ADVSOUND, Inc  
Model Difference

RE: LETTER OF MODEL DIFFERENCE

**MODEL: ADV500, ADV500-XXX (x can be blank, or hyphen, or underscore, or a-z, or 0-9)**

**FCC ID:2A7LJADV500**

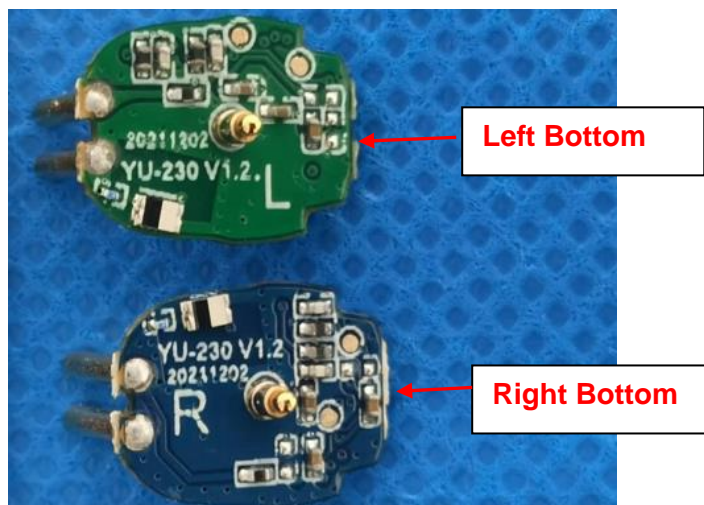
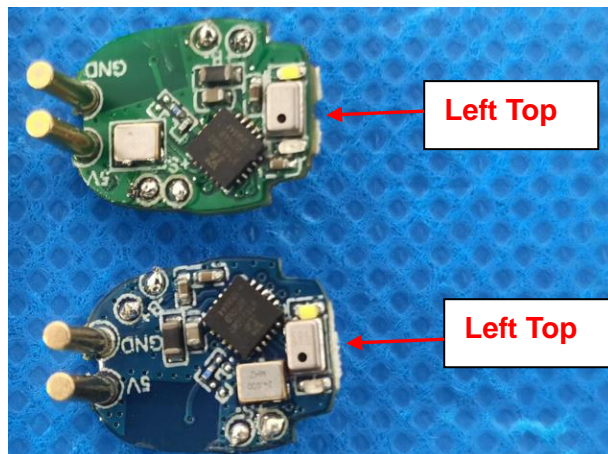
The SCH same and layout different change just for antenna for different side, not affect RF part, and test Conducted output power and Spurious RF conducted emissions in report show its no effect.
